November 19, 2022

**Re: Notice of Public Meeting/ Committee of the Whole  
OP:22.009, Z.22.018, 19T-13v006  
Comments by Consultant for the Property at 190 Doughton Road**

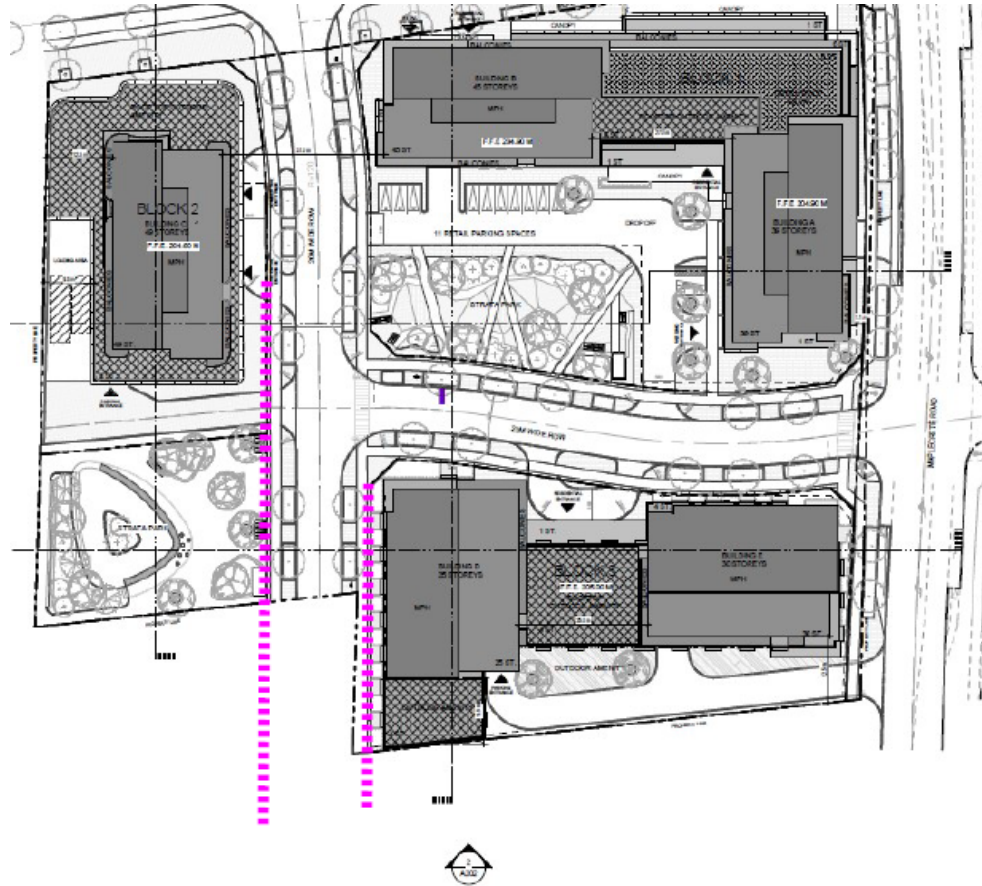
- North-South Proposed Road
  - Council approved 220 Doughton application. The ROW is aligned with the easterly property line at the site's north end.

- The proposed application has the ROW further east. (approx.. 2m)

- As such, this proposed road alignment will need to be coordinated with the 190 Doughton and 220 Doughton developments.

## 2. Block 3 Vehicular Access/ Egress

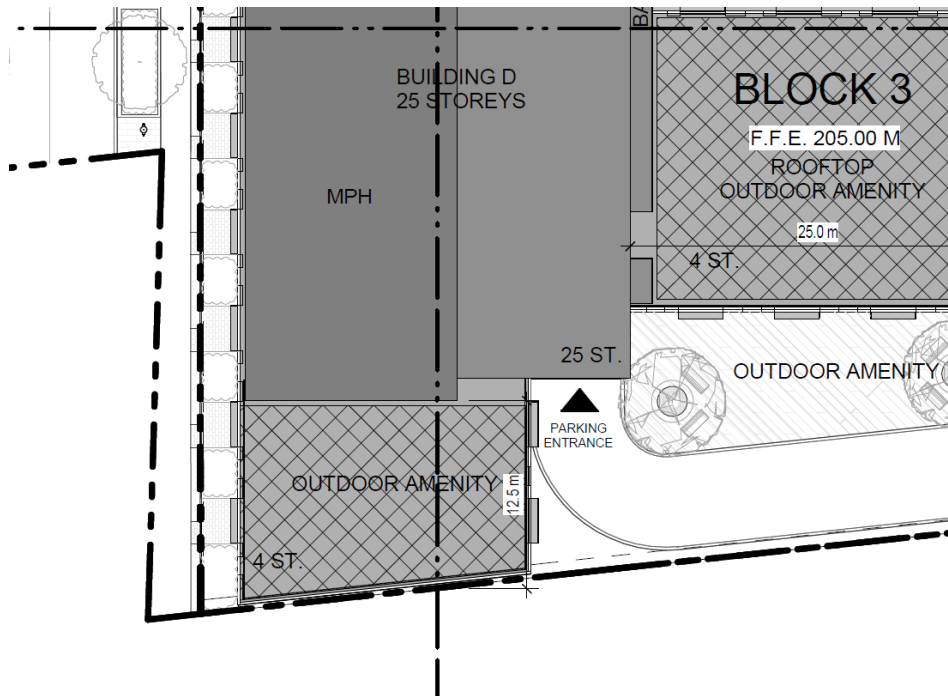
- The vehicular access and egress for two towers, 436 parking spaces and loading space are located along the southern property line with full moves into the driveway. This is a concern as the number of vehicles turning in and out of this driveway is less than 50m from the new proposed intersection. Additionally, the properties to the south will also require a driveway access along Maplecrete at the north end of the property. If not side by side, two entrances near each other will cause traffic chaos. This driveway entrance should be looked at with potential entrances of the developments to the south.

### 3. Building D's proximity to the property line

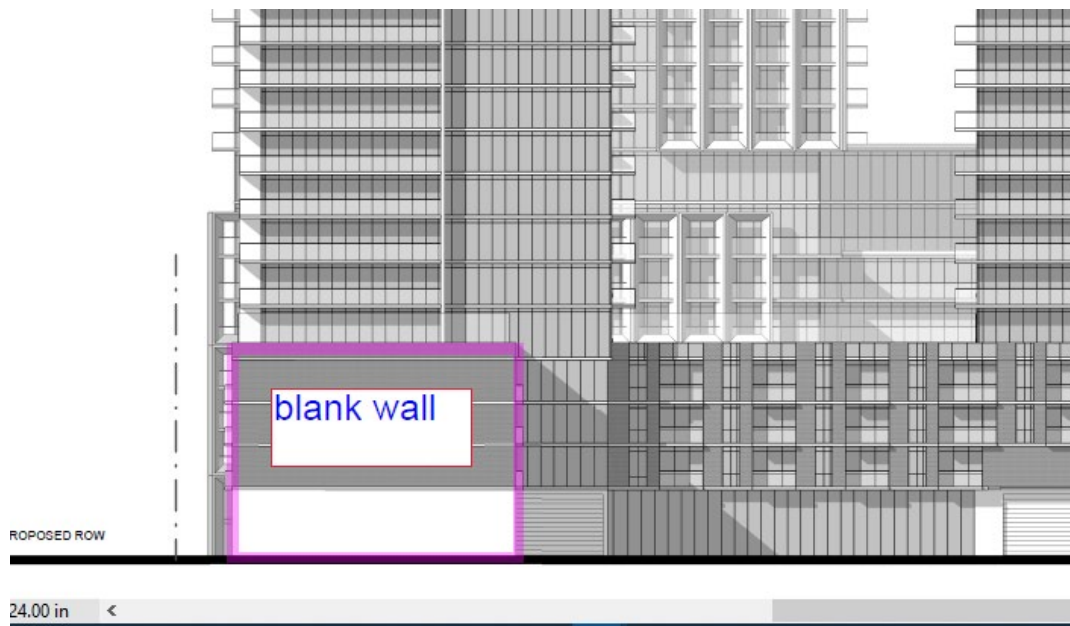
- Building D 4 storey podium seems less than 12" to the property line.

- This condition creates a 4-storey high blank wall along the property line.
